**Planning Application for
Minor Relaxation of Building Height Restriction to Construct a Car Park and an
Ancillary Plant Room at Basement Level for Permitted Residential Development
at No. 3 Lincoln Road,
Kowloon Tong, Kowloon
(New Kowloon Inland Lot No. 713)
(Planning Application No. A/K18/350)**

We submit herewith a set of replacement pages of the Application Form and "Response-to-Comments" in responding to the government departmental comment for the captioned planning application.

Response-to-Comments

SECTION AND CALCULATION

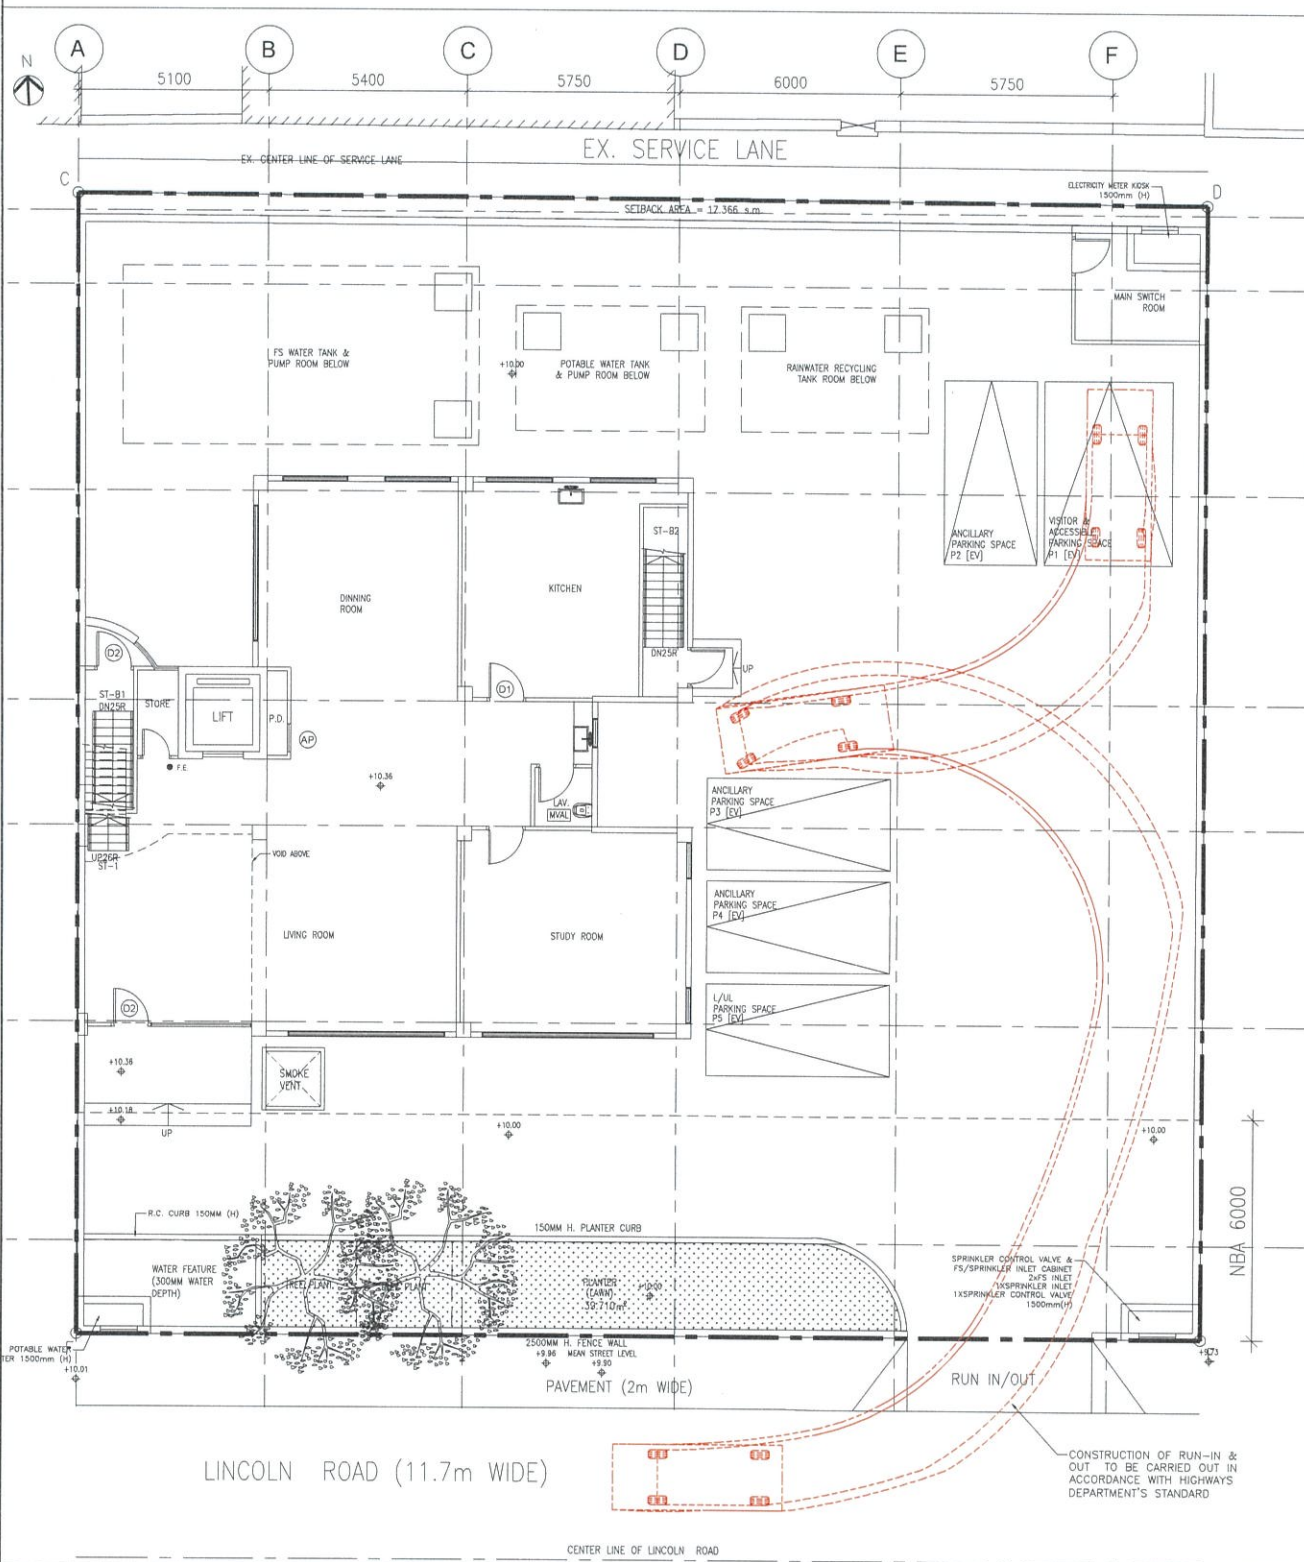
for our assessment.	
4.	<p>It is noted from paragraph 6.4 of planning statement that “Placing the proposed car parking spaces and ancillary plant rooms at the basement level can reduce the building bulk and provide more open spaces at ground level for gardening and landscaping purposes, which would definitely improve air ventilation and amenity in the area”. Please elaborate how the proposed relaxation of BHR can improve air ventilation and amenity in the area. Please also provide an alternative scheme (with car parks and plant rooms NOT in the basement) to justify the necessity of the proposed basement.</p>	<p>The proposed minor relaxation of BHR can improve air ventilation and amenity in the area due to the followings:</p> <ul style="list-style-type: none"> (a) Building bulk is minimized as far as possible by placing the ancillary plant rooms and car parking spaces at the basement, and allowing the provision of a larger greenery / landscaping area. (b) Set back of 6m from Lincoln Road in accordance with the non-building area (NBA) requirement for streetscape enhancement as stipulated under the Kowloon Tong Outline Development Plan (ODP). (c) Stepped terraced design by setting back 2/F with landscaped flat roof are provided to break down the visual bulk of the proposed development as viewed from pedestrian level, and to allow the provision of curvilinear planter connecting the different floors, which soften the building mass and also enhance the amenity of the development as well as the neighbourhood. (d) Landscaping is proposed at grade with combination of trees, shrubs and ground cover within the site, which will be visible to the public to enhance the amenity of the public realm. <p>Please see the Alternative Scheme (without basement) at Appendix 2 for showing the difference below:</p>

<p>(a) The landscape area would reduce from 193.461m² to 64.304m².</p> <p>(b) The ancillary plant rooms would have to be provided at roof level and there would be more bulky building design.</p> <p>(c) The car parking spaces and loading/unloading (L/UL) bay for meeting the requirements from the Commissioner for Transport (C for T) and the required maneuvering areas would have to be located at-grade and would occupy major portion of the open area.</p> <p>Nevertheless, the proposed basement area is reduced from 715m² to 689.165m² for minimizing the basement size. The revised proposed basement area is devised based on the functional, building services, geotechnical and structural design requirements of the house.:-</p>

SECOND FLOOR PLAN

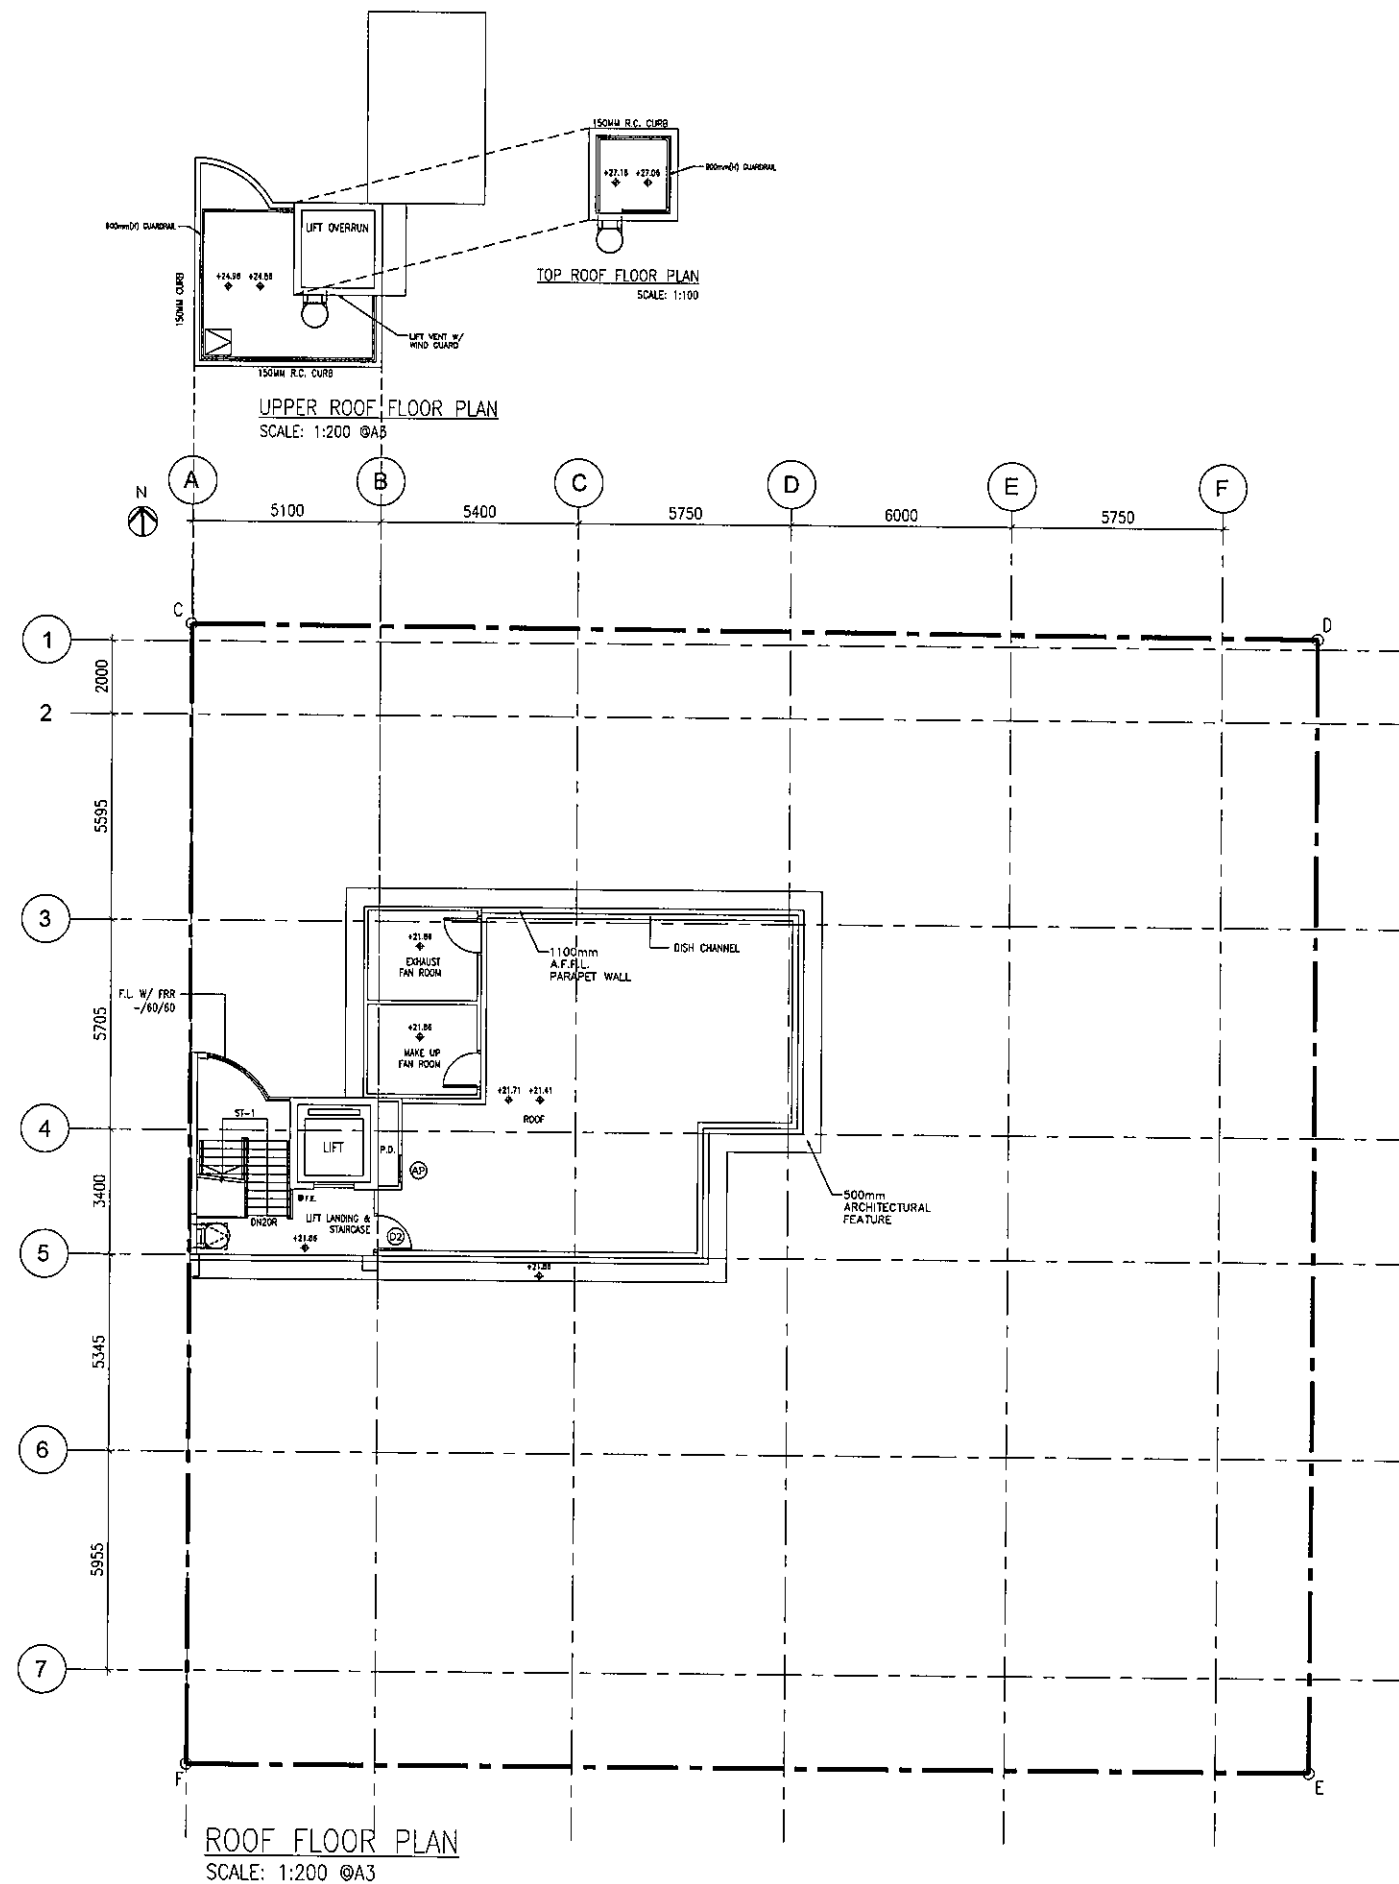
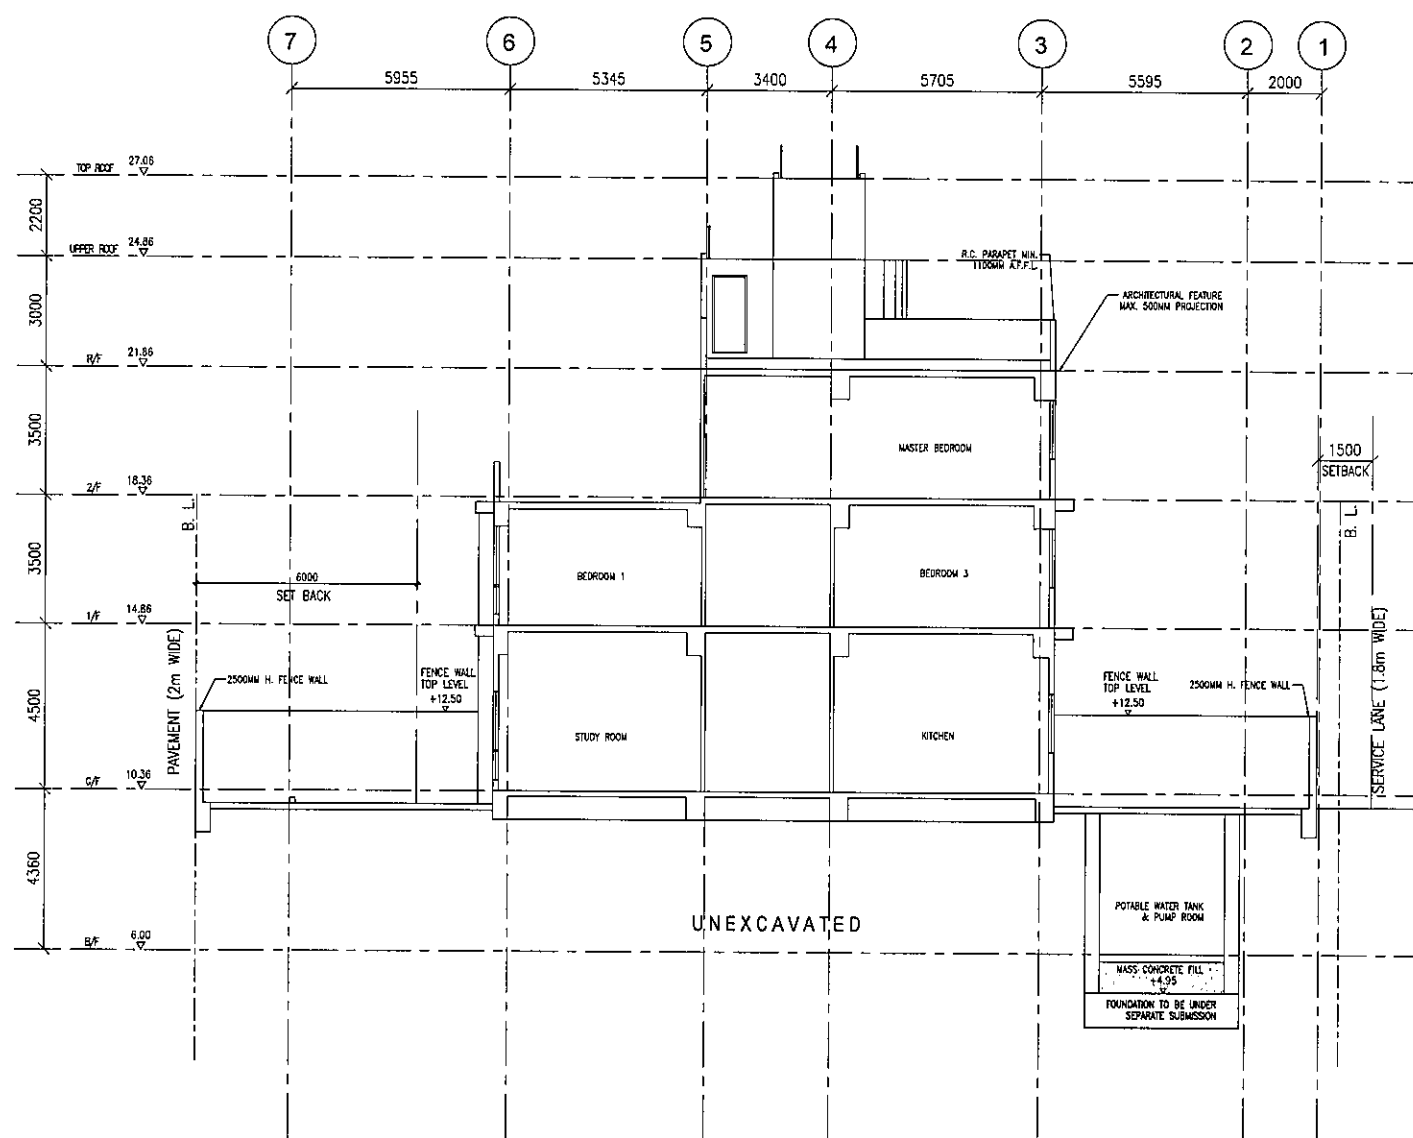
(g)	Second floor plan is not provided in Appendix 4 of	Please see the revised Proposed Layout Plans at

Planning Statement.	Appendix 1.
	<u>Architectural Services Department (ArchSD)</u>	
(1)	Based the information provided, it is noted that the proposed development mainly consists of an addition of a basement storey under a 3-storey house. As the proposal mainly pertains to planning issues which is outside ArchSD's purview, we are not in position to comment on it. Nevertheless, we would be glad to offer our advice when specific architectural or visual aspects of the case is called for.	Noted.
	<u>The Geotechnical Engineering Office (GEO) of Civil Engineering and Development Department (GEO, CEDD)</u>	
(1)	The Geotechnical Engineering Office (GEO) has no adverse geotechnical comment on the application.	Noted.
	<u>Electrical and Mechanical Services Department (EMSD)</u>	
1.	No Comments from our regulatory services perspective.	Noted.

Master Landscape Plan

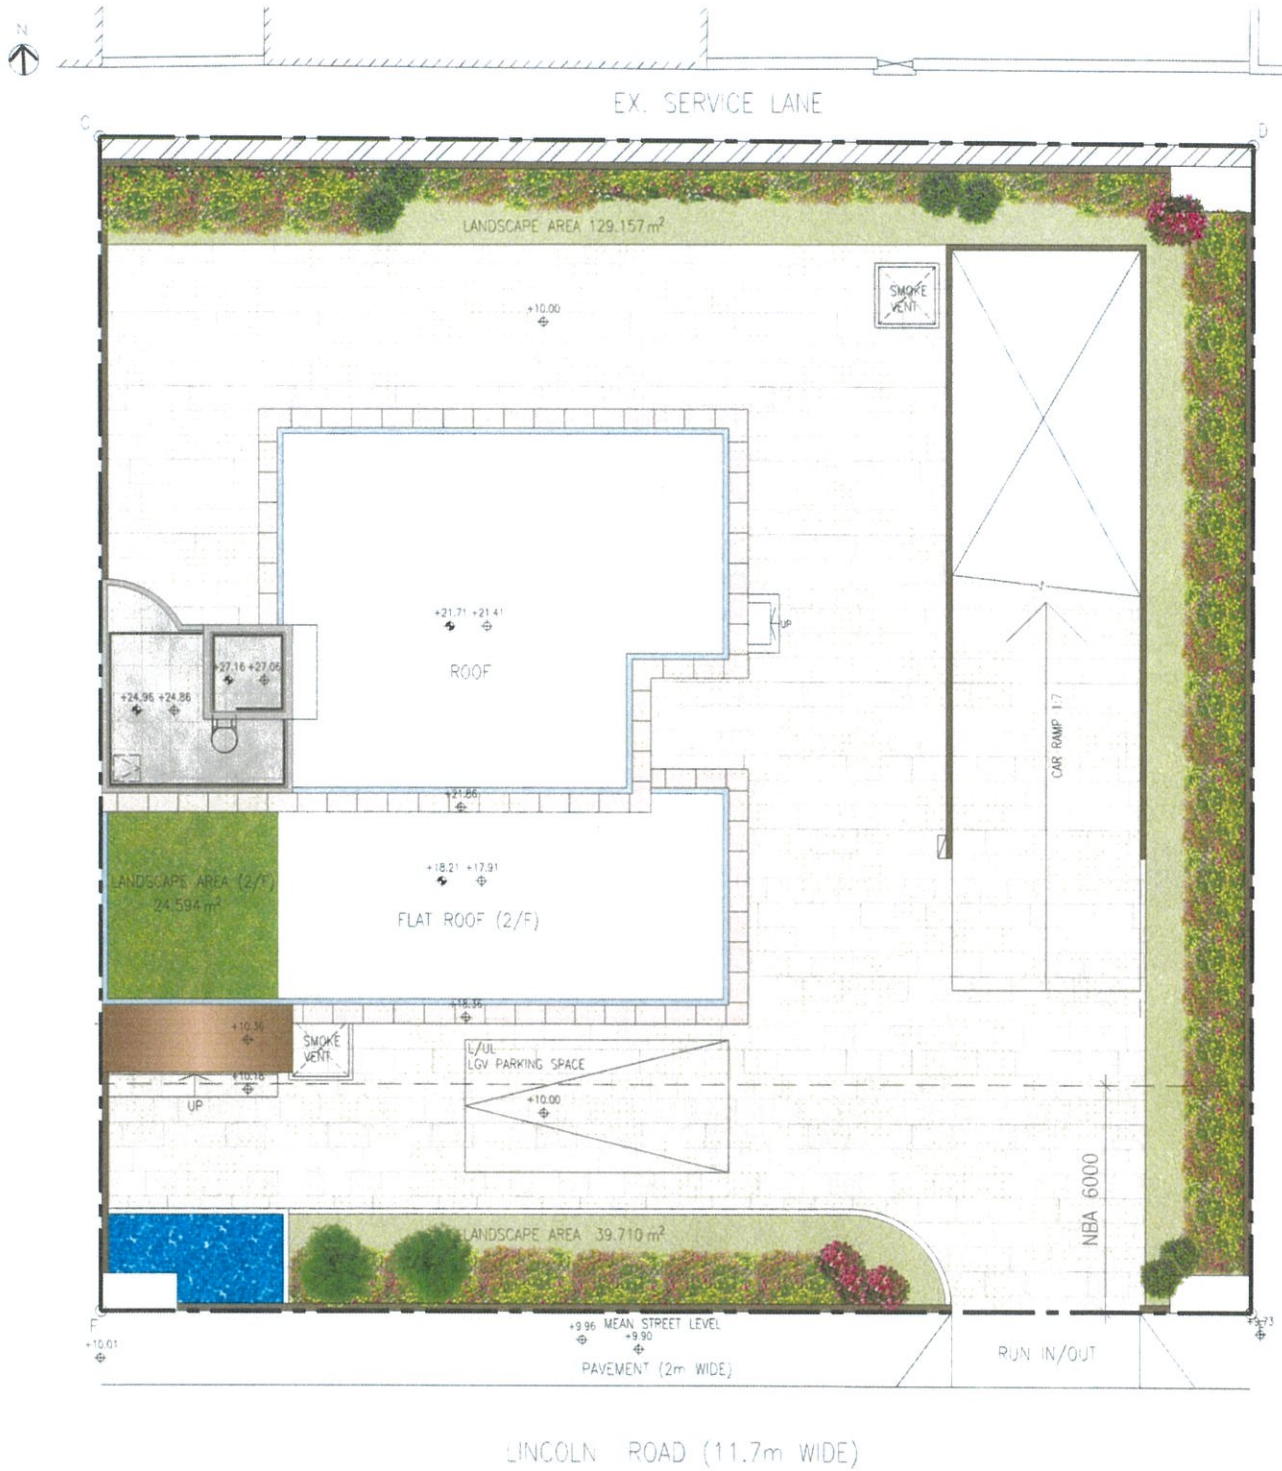
3.	It is mentioned in paragraph 6.5 of planning statement that open landscaped area will be provided at ground level, however, no detailed information about the proposed open landscaped area was included in the planning statement. Please elaborate. Please also provide a landscape design proposal clearly demonstrate the landscape treatment and greenery ratio	Please note that there would be about 20% greenery ratio (about 193.461m ²) provided in the proposed development. Please see the Landscape Proposal at Appendix 3 .

1.	Based on the aerial image of GIH in 2024 and street view in Google Map in 2023, the site was covered with lush planting of trees. The applicant should clarify for the missing trees in the current application.	Please note that the previous trees were dead. However, two new trees are proposed in the application. Please see the Landscape Proposal at Appendix 3 .

2.	According to para. 6.4.1 of the current application, it was mentioned that the proposed development could provide more open spaces at ground level for gardening and landscaping purposes. The proposed landscape areas should be demarcated on plan for reference. The Applicant is also advised that sufficient soil depth (at least 1200mm) should be provided for at-grade tree planting.	<p>Please note that sufficient soil depth (at least 1200mm) would be provided for at-grade tree planting.</p> <p>Please also see the Landscape Proposal at Appendix 3.</p>
